Vastern Court: Daylight and sunlight

Dr Paul Littlefair
BRE

17-29 Vastern Road (Figure 4 in my proof CD10.4)

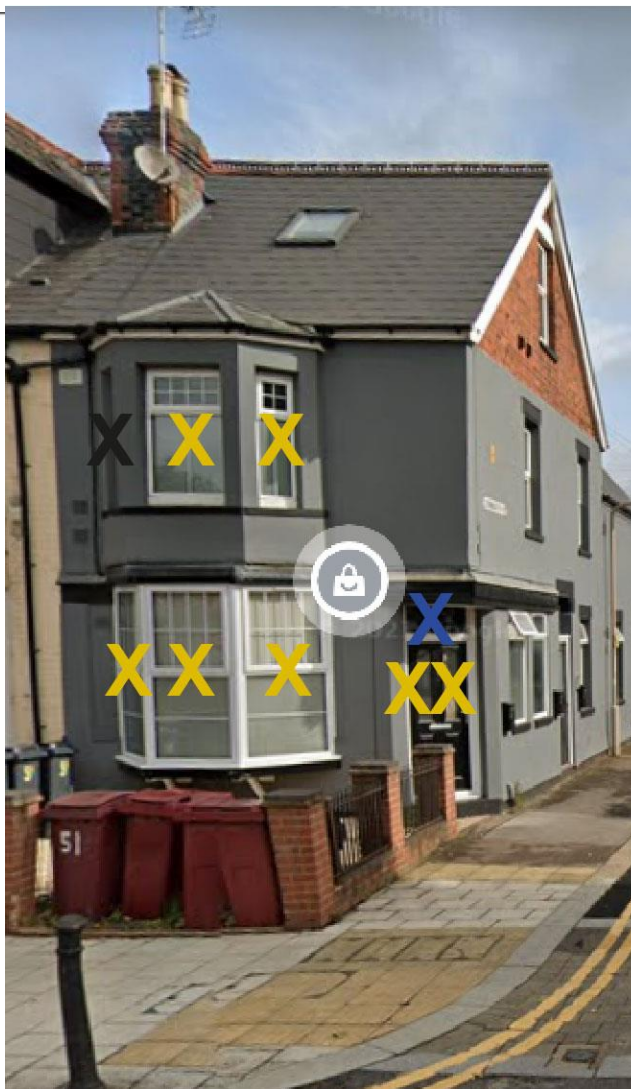
- Loss of VSC to all 57 windows analysed at 17-49 Vastern Road would be outside the BRE guidelines. 39 of these windows would have relative reductions of 33.0-39.8% and the other 18 windows would have relative reductions of 40% or more.

- Effects on daylight distribution would be outside the BRE guidelines for 36 of 50 rooms analysed in 17-49 Vastern Road. 11 of these would have impacts more than double the BRE recommendation.

51 Vastern Road (Figure 6 in my proof CD10.4)

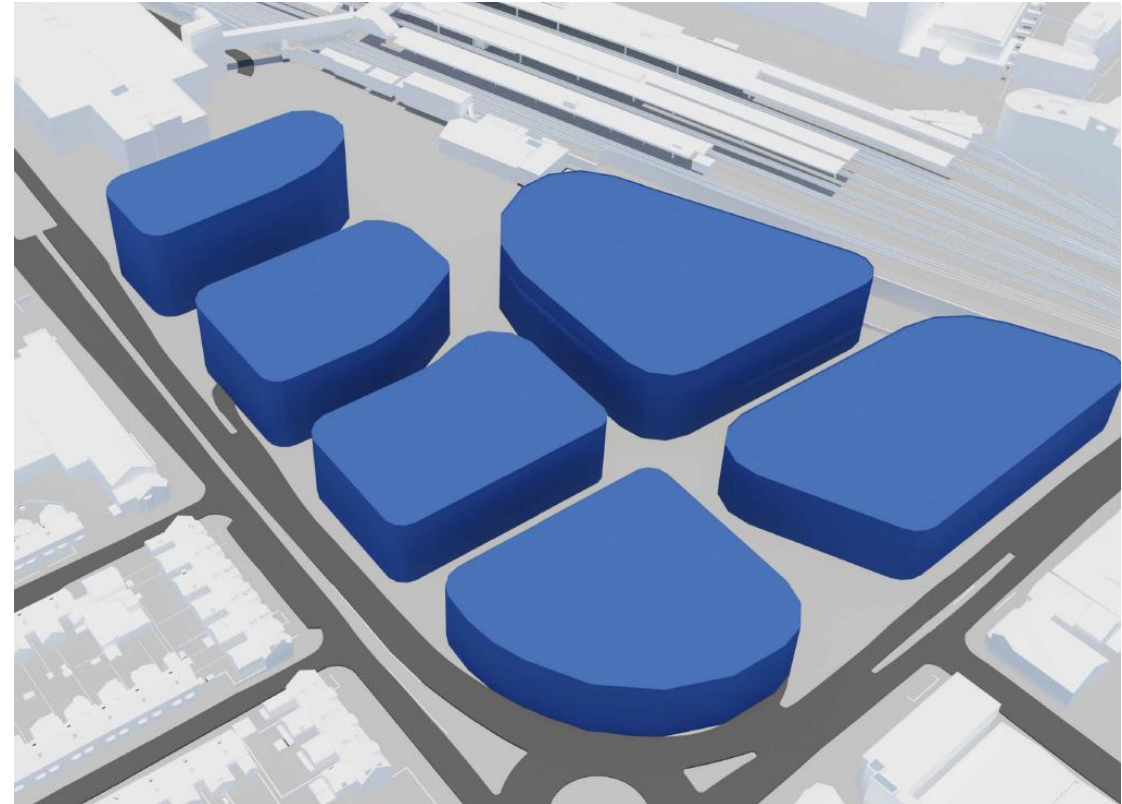
Losses of VSC to nine windows at 51 Vastern Road would be outside the BRE guidelines.

Eight of these windows would have relative reductions of 26.7-36.5% and one window would have a relative reduction of 73.9%, though this is a secondary window lighting the doorway and it has an overhang above it.

Daylight in Illustrative scheme - example

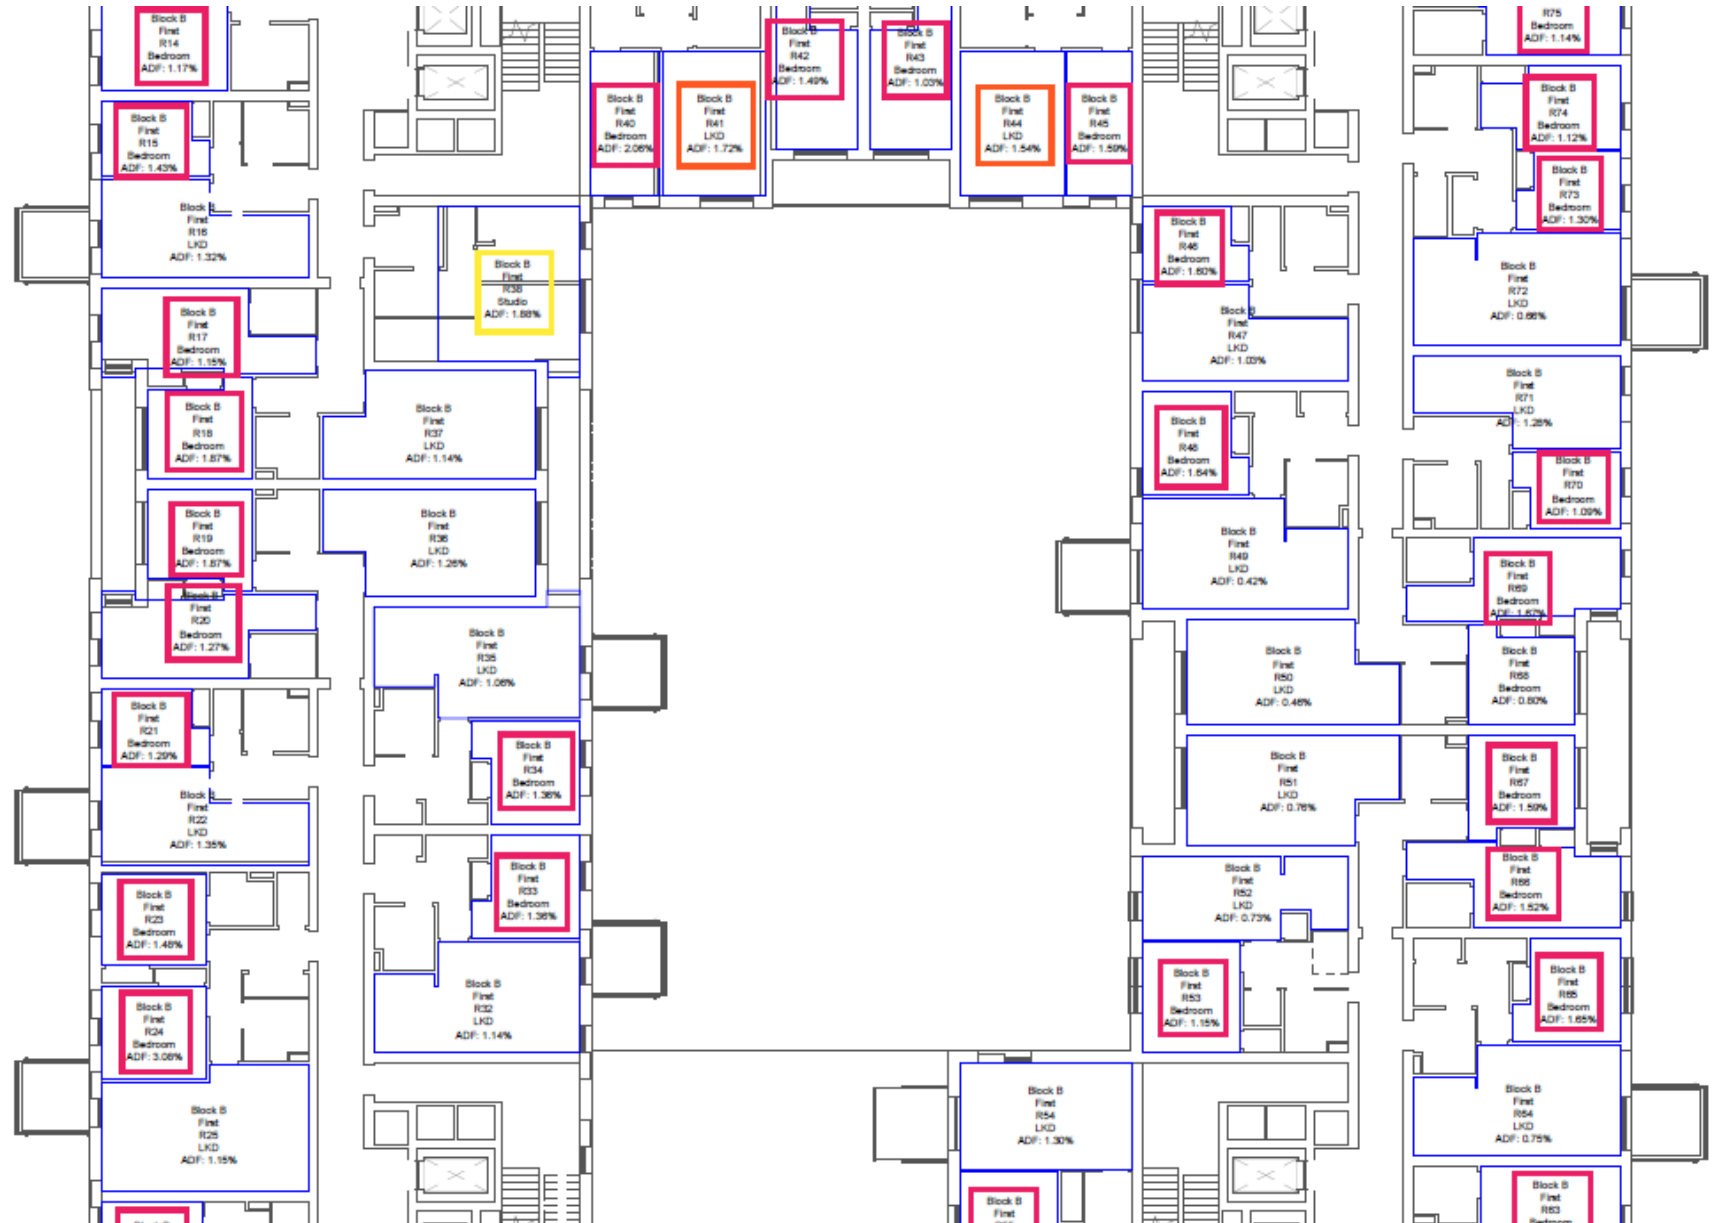
- Example for part of Block B first floor
- Uses unrealistic frame factor of 0.9 so will overestimate ADFs
- Unlabelled rooms indicate LKDs with ADF below 1.5% minimum
- Orange rooms are LKDs with ADF between 1.5% and 2%
- Green rooms are LKDs with ADF > 2%
- Magenta rooms are bedrooms with > 1%

Loss of light to 55 Vastern Road (SSE scheme)

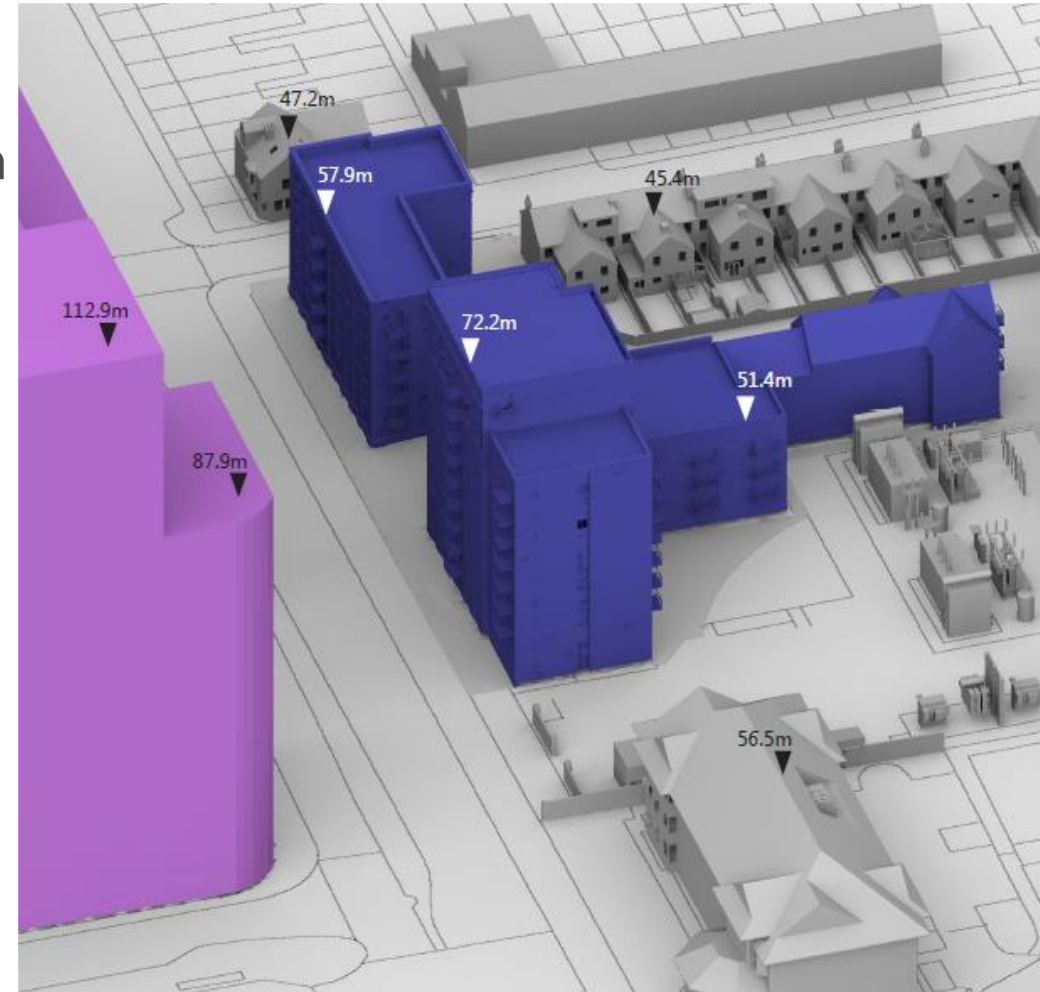
- Of the 12 living rooms analysed facing the Appeal scheme, 11 would have average daylight factors below the minimum recommendation, compared with five of these rooms with the current retail park. (The lowest ADFs are 0.4%, not 1% as stated in my rebuttal proof paragraph 5.3).
- The Appeal Scheme would therefore result in inadequate daylight in living rooms in the 55 Vastern Road scheme.
- Annual sunlight to seven of these living rooms and winter sunlight to eight would be below the BRE recommendations with the Appeal Scheme in place.
- Ten living rooms in total would have losses of sunlight outside the BRE guidelines, with eight of these losing more than half their sunlight.

Drawing by Eb7 from Appendix D of Appellant's Position Statement (CD8.16)

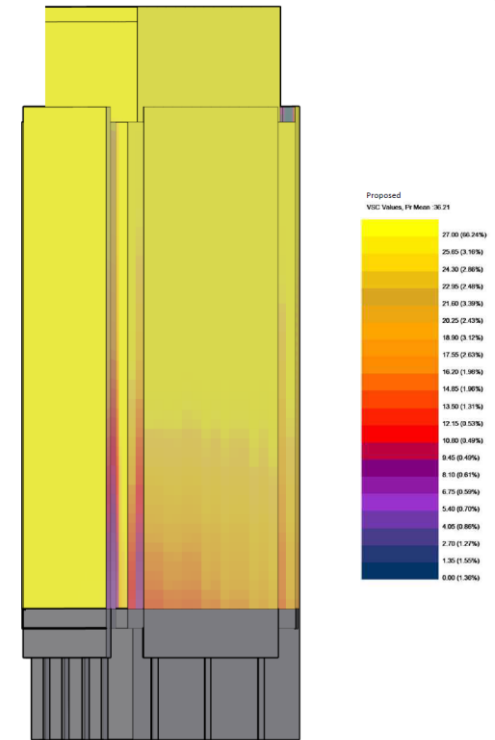
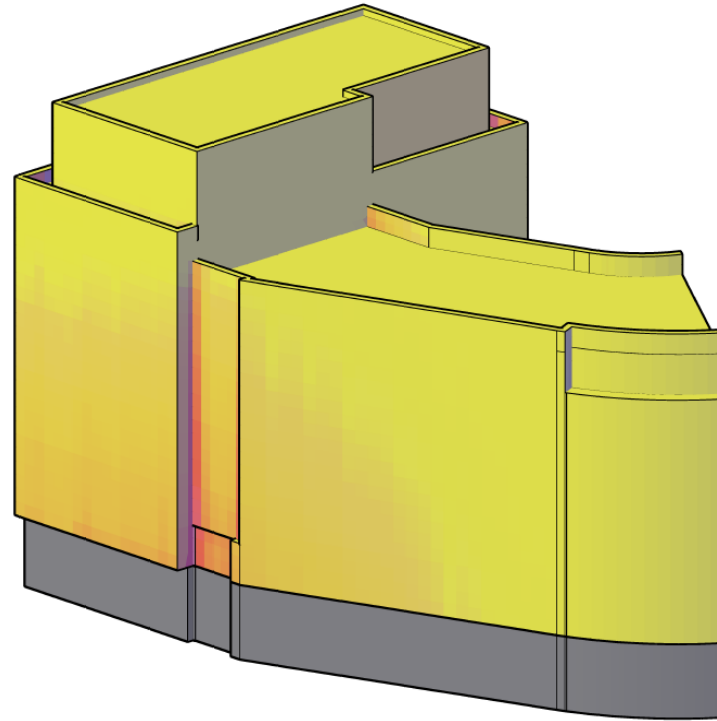
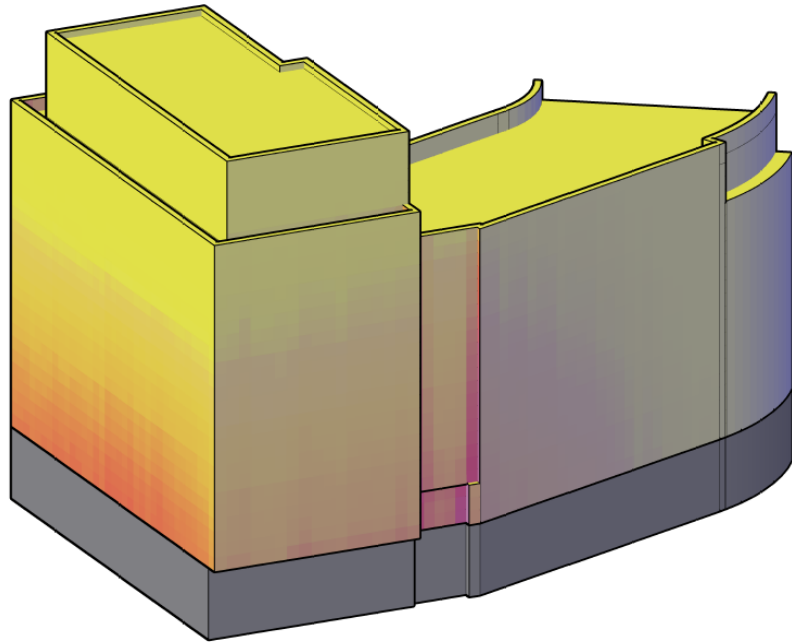
- The only data are in coloured diagrams indicating vertical sky components (VSCs). The shading on the drawings is not clear and it is not possible to judge accurately what the VSC might be at any particular point.
- The proposed Appeal Scheme will have an impact on 80 Caversham Road. But it is not possible to tell how large that impact will be, or whether future residents there would have adequate daylight with the Appeal Scheme in place.
